Proposed Addition to the Integrating Receiver Proposal

Figure 1.

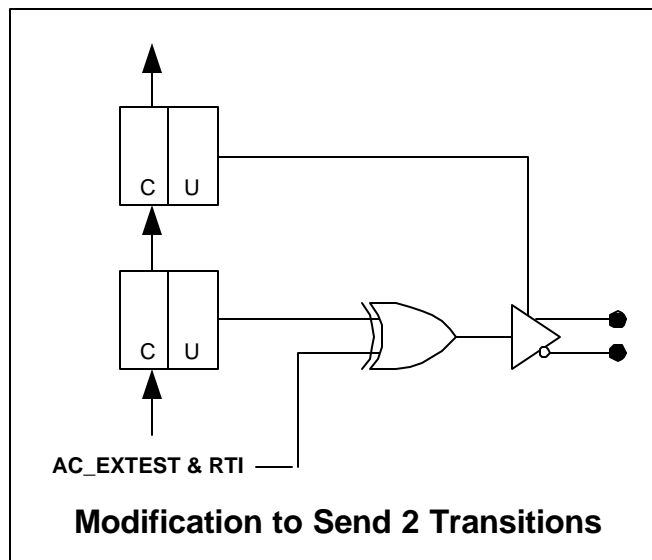
First, modify the driver boundary cell by adding an Exclusive_Or between the update latch and the output to the driver. The second input to the Exclusive_Or would be (AC_EXTEST & RTI). Upon entry to the RTI state in AC_EXTEST, the driver output would toggle to the opposite of the value in the update latch. Upon exit from the RTI state in AC_EXTEST, the driver would again toggle back to the same value in the update state. These extra transitions could be avoided by not transitioning the RTI state. See Figure 1.

Figure 2.

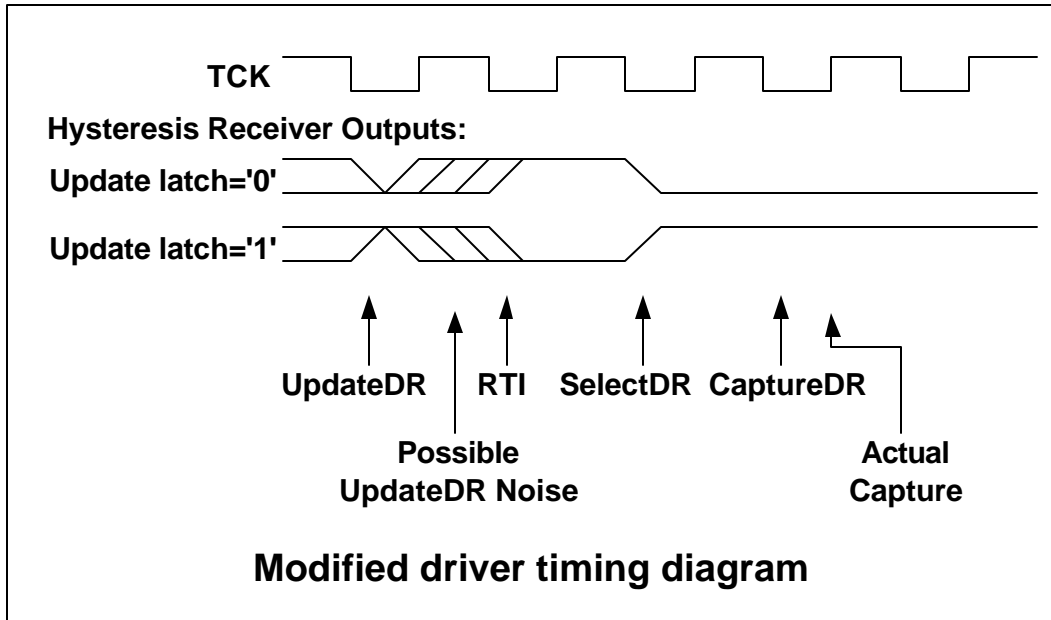
The timing diagram for this modification to the driver is shown in Figure 2. This shows only a single cycle spent in RTI, but that is not significant for the proposal. It could be many cycles. It also shows the hysteresis receivers at an unknown state prior to UpdateDR, and affected by noise after UpdateDR.

Figure 3.

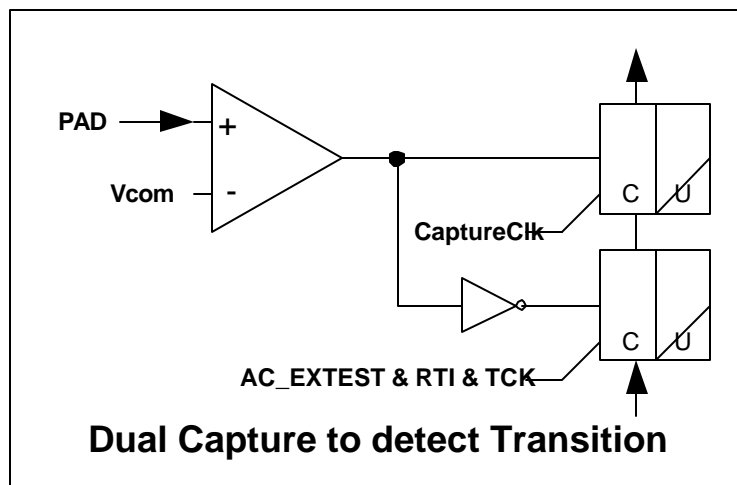
Second, add an additional flop in the receiver boundary cell that captures the value on the pad at the rising TCK during RTI. The output of this flop can be used to “clobber” the value captured at CaptureDR. Alternately, the inverted value on the net may be simply captured in a separate observation cell in the boundary scan chain. See Figure 3. (This addition requires the first, but is much less important than the first.)
